Resolution PZ 02-2019, Series of 2019
Dillon Homewood Suites PUD Development Plan
Major PUD Amendment

Exhibit ‘C’
Architectural Review

RSA REVIEW
3/21/18

Lake Dillon Homewood Suites

Sheet:
A3.5
ROOF LEVEL OVERALL PLAN

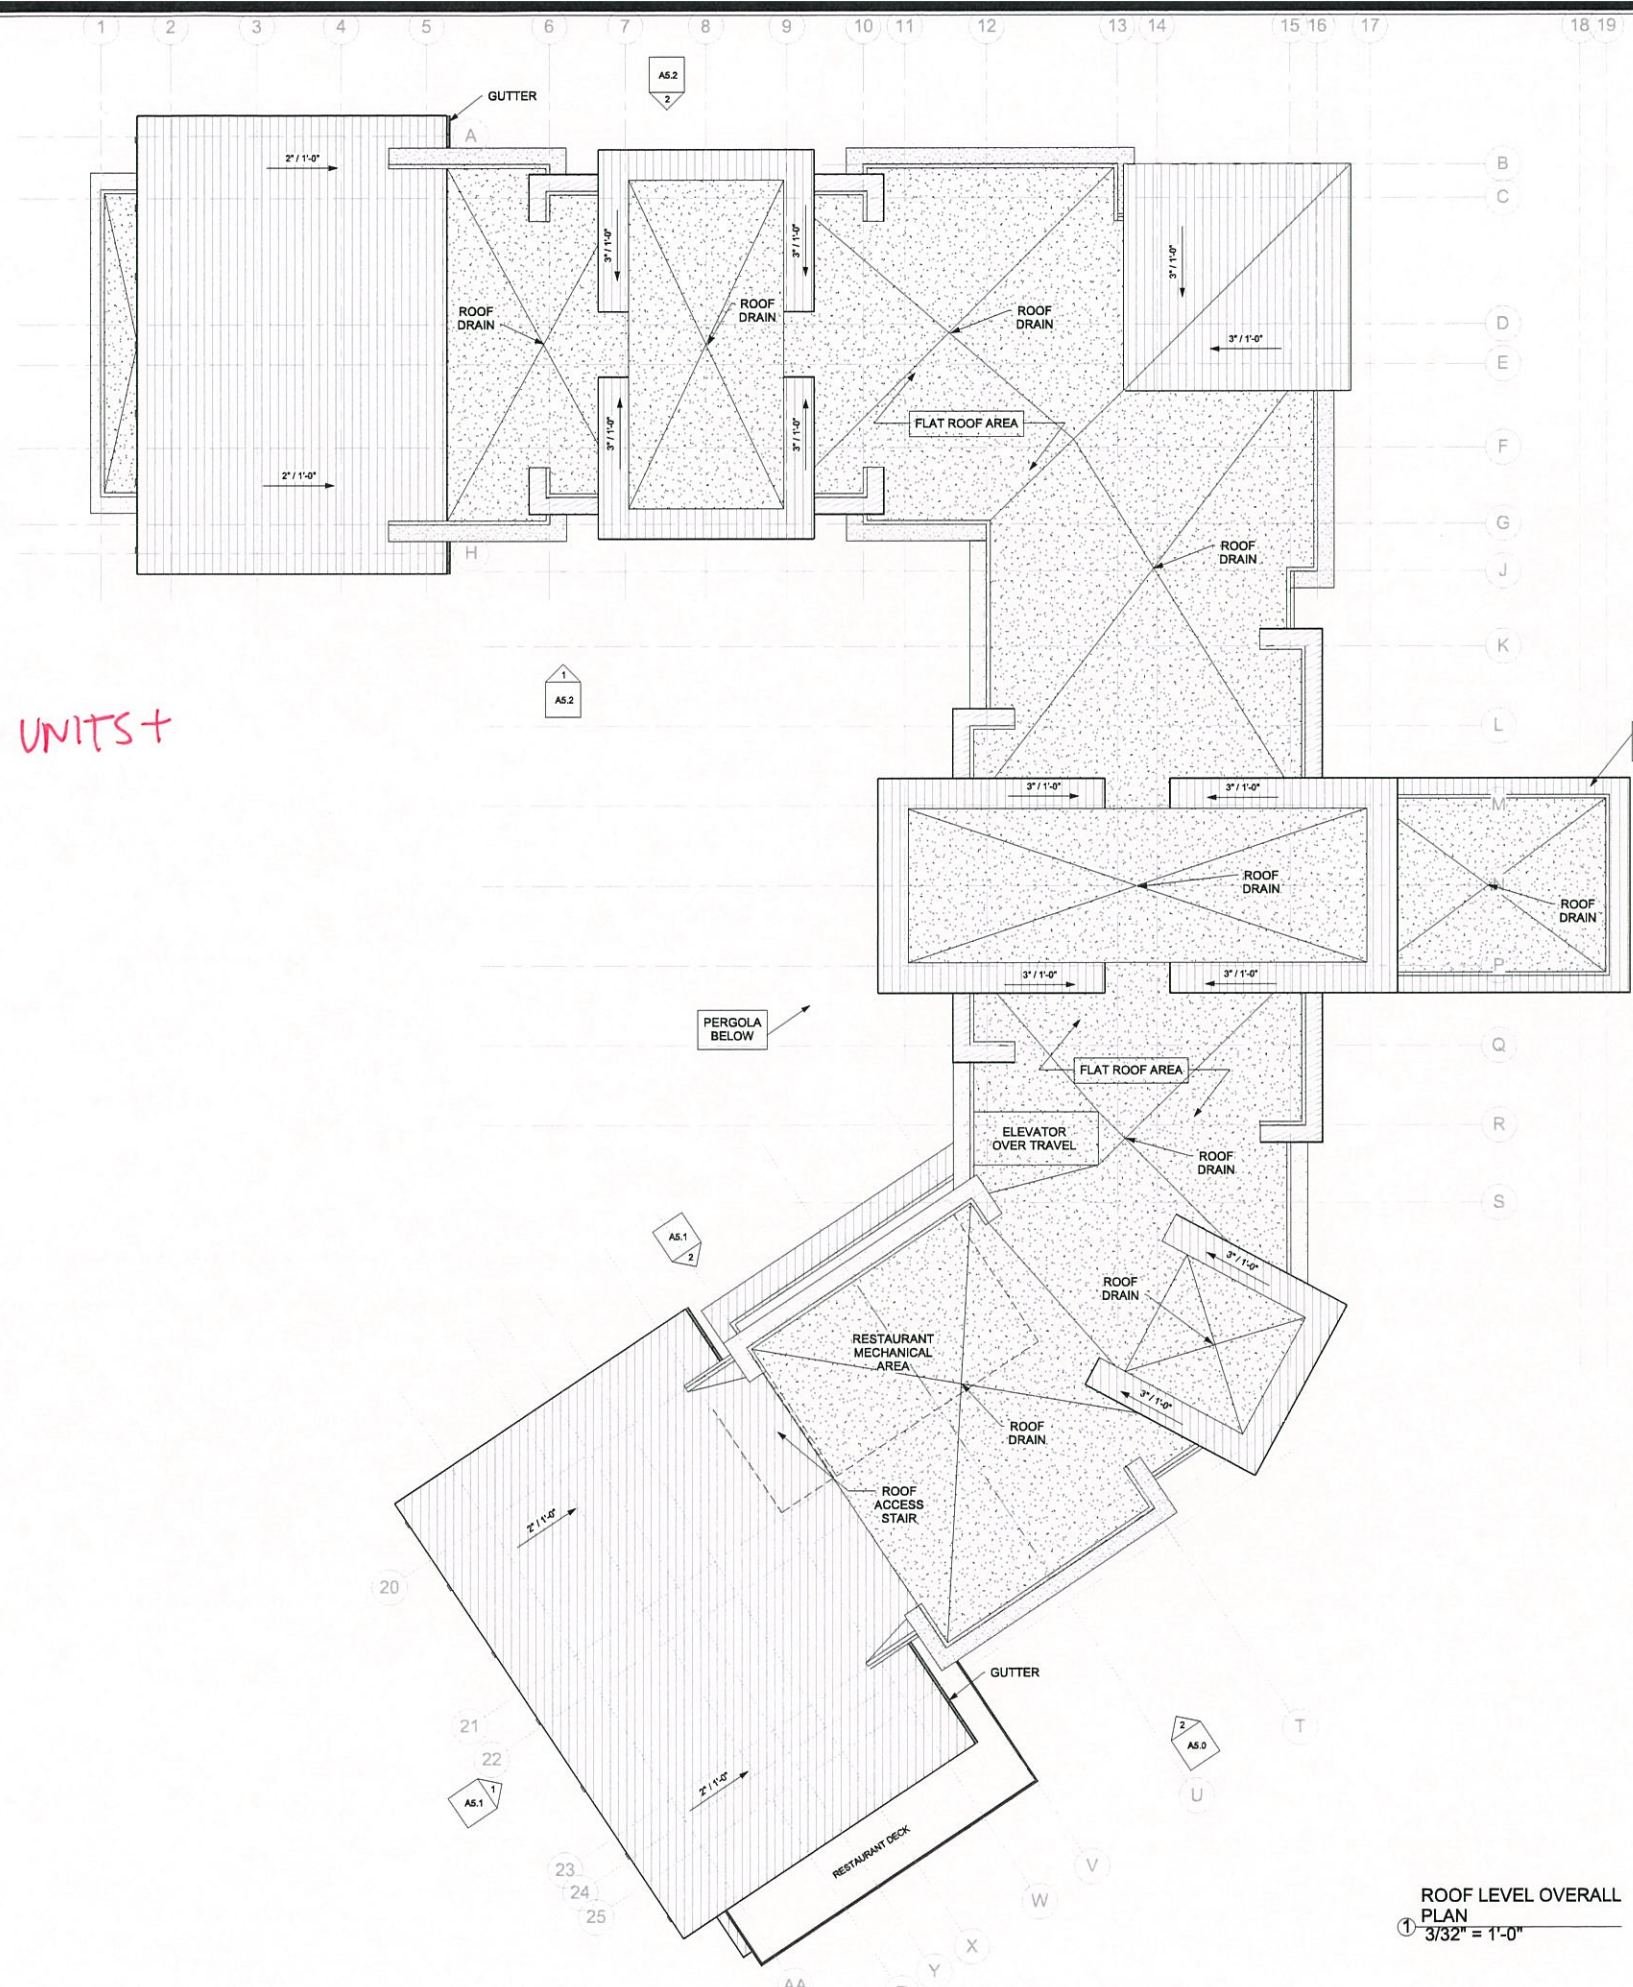
SHOW ZONES/
SHOW AREAS FOR MECH UNITS +
INDICATE HEIGHTS

NEW HOMEWOOD SUITES DESIGN

ON PREVIOUS DESIGN HAD A MORE SUCCESSFUL SOLUTION TO THE ROOF WITH A MAJOR ROOF SUPPORTED BY MINOR ROOF FORMS.

PRESENT SOLUTION IS ALL MINOR ROOFS, ALL OF EQUAL IMPORTANCE. DOES NOT MEET DESIGN CRITERIA.
